Triton project

2021 05 27

Beauty Commission – agreed upon appearance

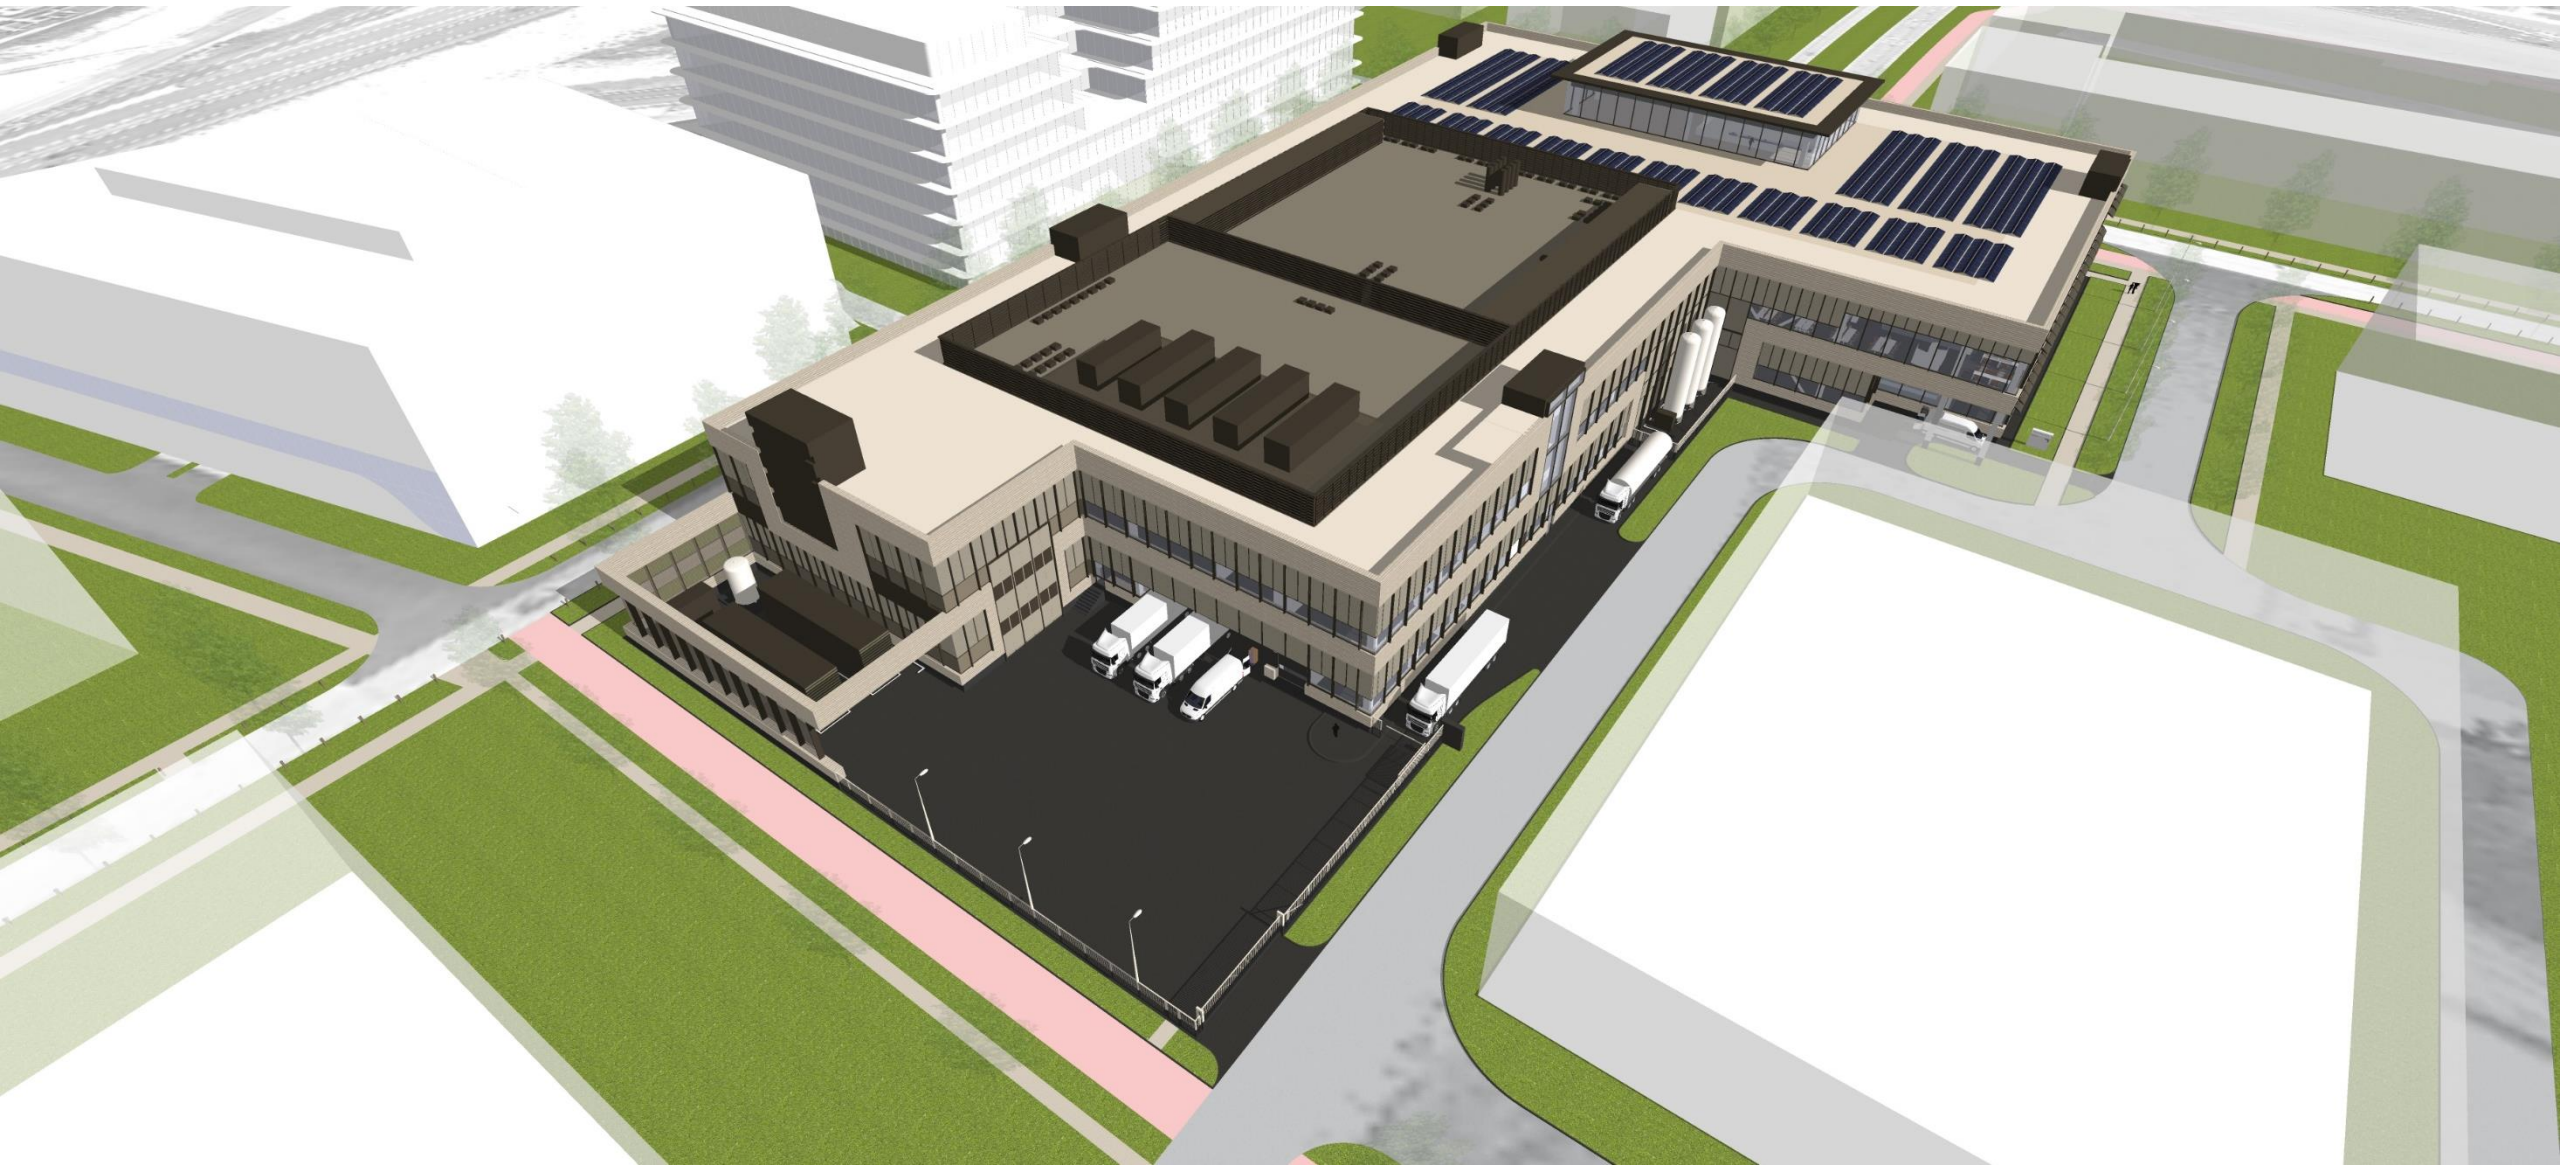
1. **Canopy.** The height of the canopy will be lowered to align with the upper louvre / bottom of the closed panel. This in order to have a better balance at the entrance façade.

2. **Screens.** The material of the screened area to hide the generators from view will be similar to the metal panels used above the windows. But with the exception that they will be perforated to fulfill the functional needs. This to guarantee a more uniform appearance.

3. **Chillers.** The chillers on the roof will exceed the height of the acoustic fence, the color will be dark to keep a visual unity with the acoustic screens.

4. **LN2 tanks.** The LN2 tanks are integrated into the total design of the building. The building façade design now “reacts” on the position of the LN2 tanks and folds away at their location. In this way the tanks are not merely positioned in front of the façade but are forming a dialogue.

5. **Acoustic fence.** The acoustic fence on the roof will have one visual appearance, either horizontal or vertical.
6. **Axis ending.** The building is the entrance of the west side of the LBSP. The glass façade in the middle is not aligned with the two roads and the green axis in between, but it is with the central axis of all traffic lanes (including bikes). To also give an answer to the ending of the green axis an extra element will be introduced. Further elaboration will take place based on this principle.

Same color and material. The difference will be a perforation

Façade - Southwest

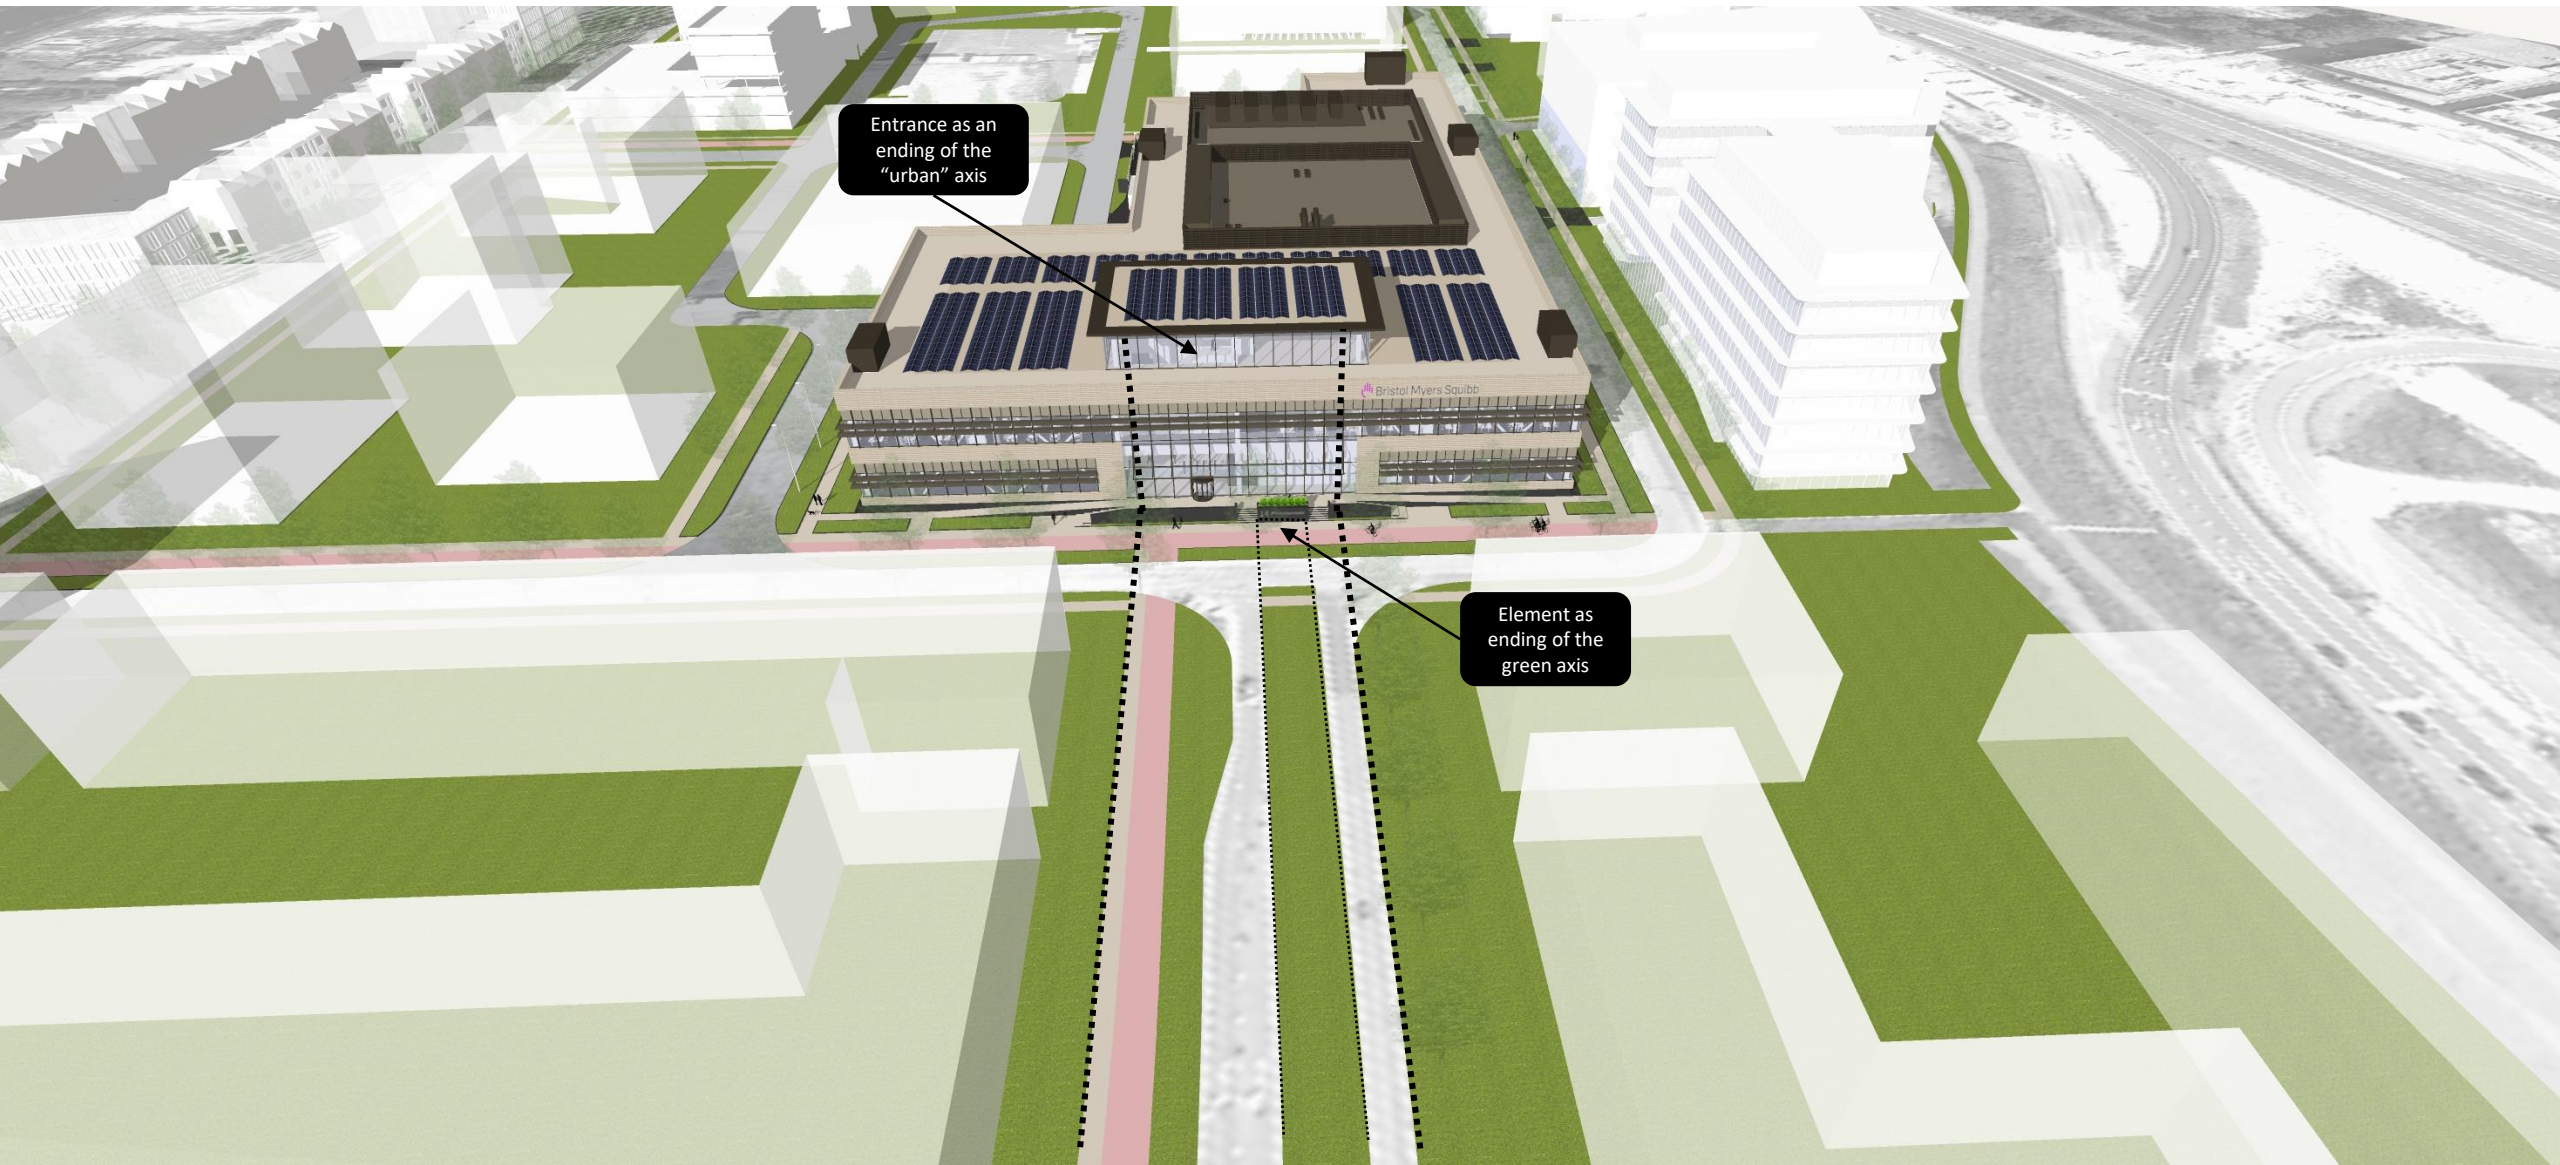
Element as ending of the green axis. Further elaboration will take place based on this principle.
